DRAFT PLANS
for pricing only
CCO 36 Sheet 1 of 6
Date 5/23/07

SAN FRANCISCO OAKLAND BAY BRIDGE
EAST SPAN SEISMIC SAFETY PROJECT
SELF-ANCHORED SUSPENSION BRIDGE
(SUPERSTRUCTURE & TOWER)

TOWER ANCHORAGE DETAILS NO. 2

SAN FRANCISCO OAKLAND BAY BRIDGE
EAST SPAN SEISMIC SAFETY PROJECT
SELF-ANCHORED SUSPENSION BRIDGE (SUPERSTRUCTURE & TOWER)
TOWER ANCHORAGE DETAILS NO. 8

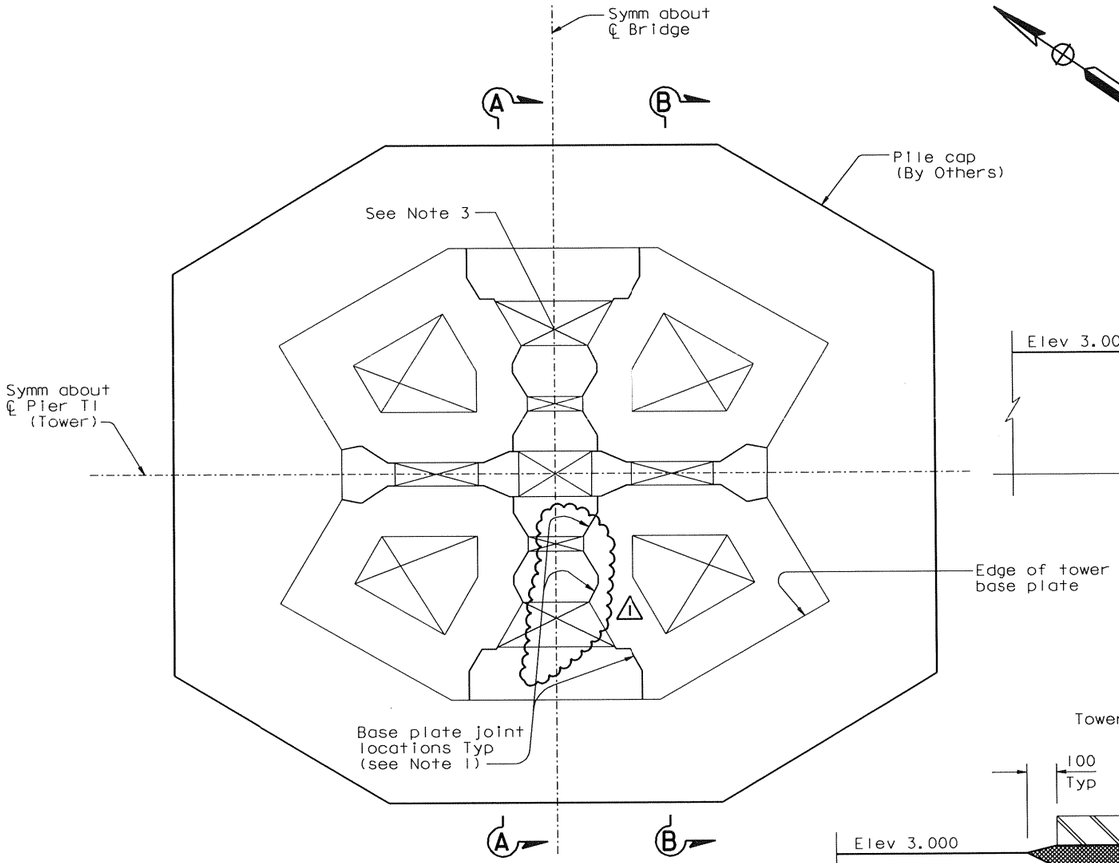
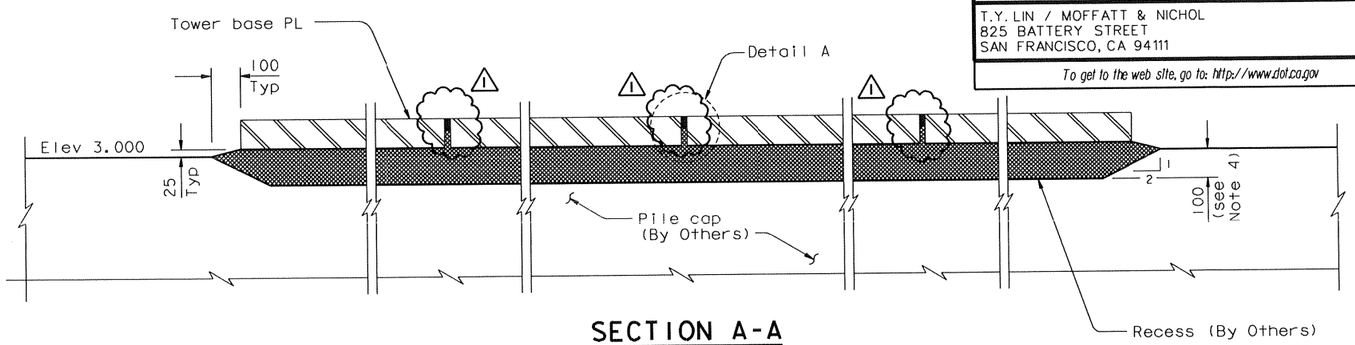
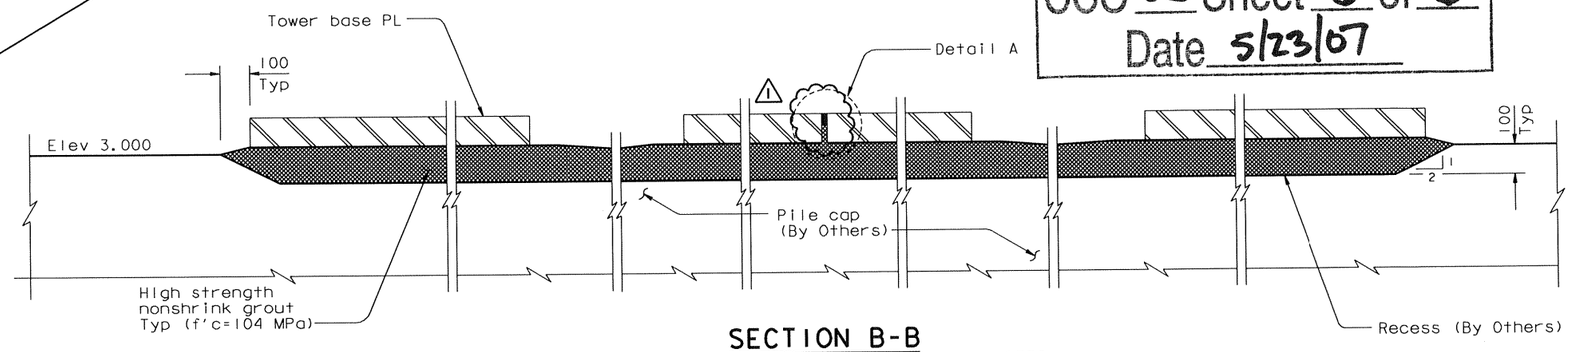
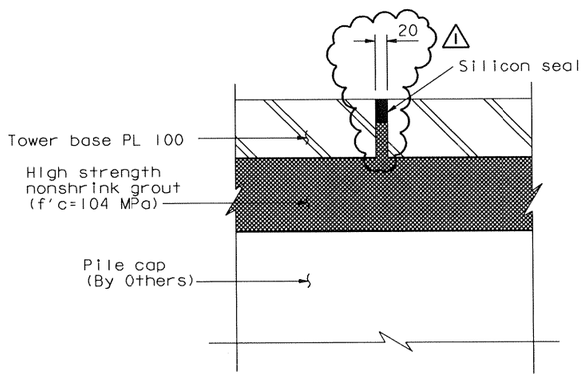
MARK	DATE	DESCRIPTIONS	BY	CH'D	CCO#
1	02/28/07	TOWER BASE PLATE	AS	MN	36

1. For layout of tower base plate joint, see "Tower Anchorage Details No.2" sheet. The Contractor may provide an alternative layout subject to the review and approval of the Engineer.
2. Base plates under each tower shaft and each shear plate shall be single plates or shall be built up from pieces by CJP welds done in the shop.
3. For tower drainage, see "Tower Drainage Details" sheets.
4. The Contractor may vary the depth of grout in order to achieve specified tolerances, provided there is positive flow towards the drains and the elevation of the top of the tower base plate is higher than the top of the drain.
